**Report: TAB REPORT
Function: Test, Adjust, & Balance
Date: 04/05/2023**

**PROJECT
03-27-23 FREDDY'S - JASPER, AL
NEED
NEED, AK**

**Client
ERC Development, LLC**

KEF2DrainPipe.jpeg

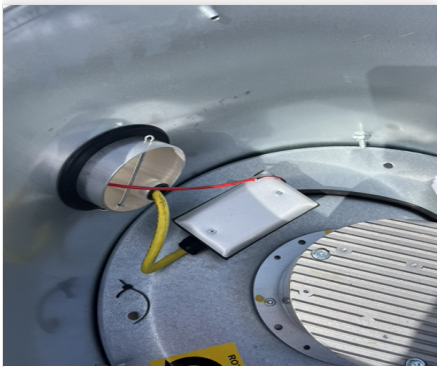
Issue Name :	KEF2 drain pipe is not centered to drain pain.		
Description :	Recommended to complete drain pipe into center of hole.		
Created By :	National TAB	Assigned To :	National TAB - Will Turnbough
Status :	Open		
Originated Date :	03/29/2023 - Ian Fuller - National TAB
